**ITEM 3.3: DA2020/0107 - 103 Narrabeen Park Parade, Mona Vale –  
Alterations and Additions to a Dwelling House**

## **SUBMISSION TO DA 2020/0107**

### **Impacts at 160 Narrabeen Park Parade, Mona Vale from the proposed alterations and additions at 103 Narrabeen Park Parade, Mona Vale**

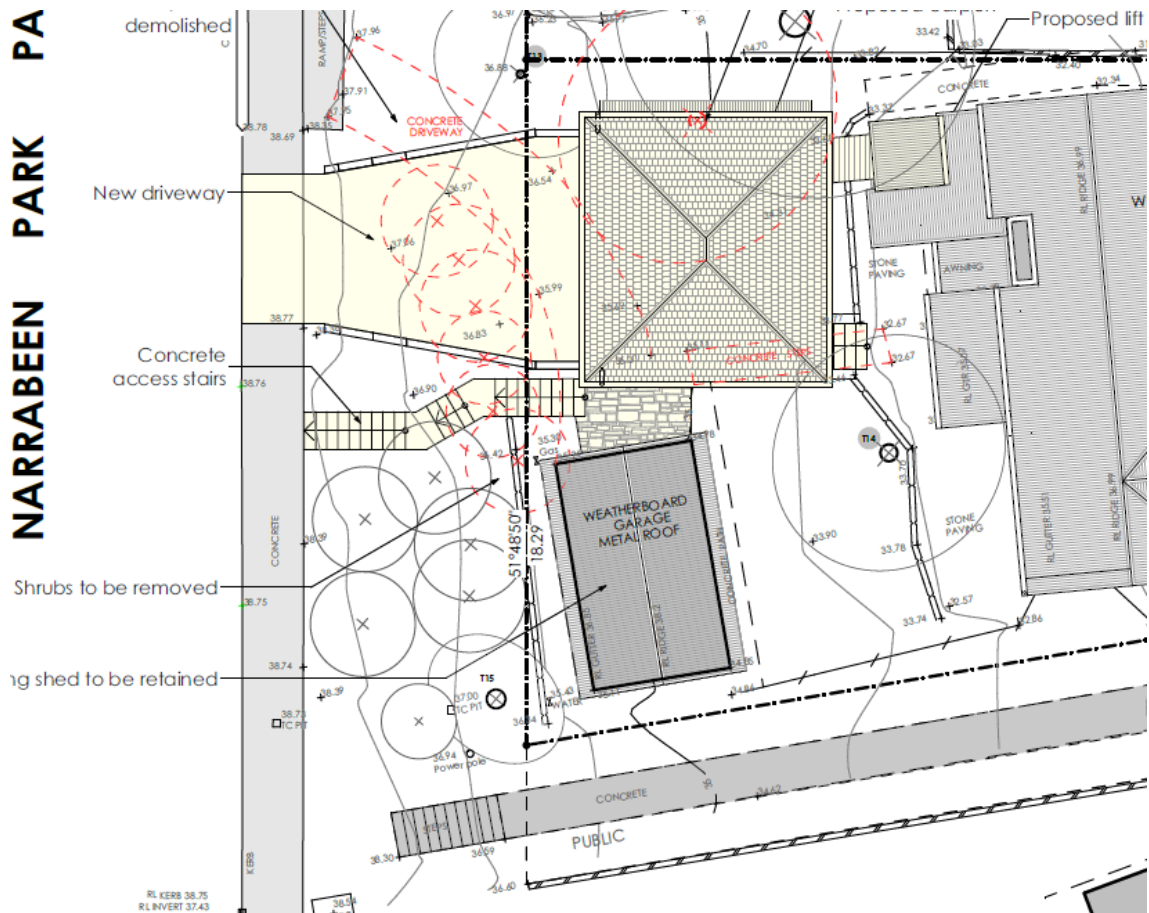
- The proposal seeks to retain the existing detached structure located adjacent to the front boundary. We submit that this limits the options for an alternative siting and design that would achieve a lower height structure. It will also result in structures (existing and proposed carparking structures) dominating the streetscape presentation contrary to the controls that seek for landscaping to be the dominant physical and visual elements (Figure 3 below).

- Demolition of the existing 'original' garage. Its removal would increase the proportion of landscaped area at the street frontage, enhance the streetscape, assist in maintaining the existing level of coastal views from the level of the pedestrian path / roadway, retain the established pattern (location and height) of garage structures within the front setbacks on nearby properties.
- Increased gradient of the driveway. The proposed gradient is less than the maximum thresholds, whereas this can be increased and still meet safety requirements. Furthermore, the 18.29m width of the site is generous enough to accommodate a curved driveway and car port entry that faces 90 degrees to the roadway.
- Lower height of the structure, flat metal deck roof in place of the proposed pitched roof, lower floor to ceiling heights (or entire removal of the 'storage room' level under the proposed garage.
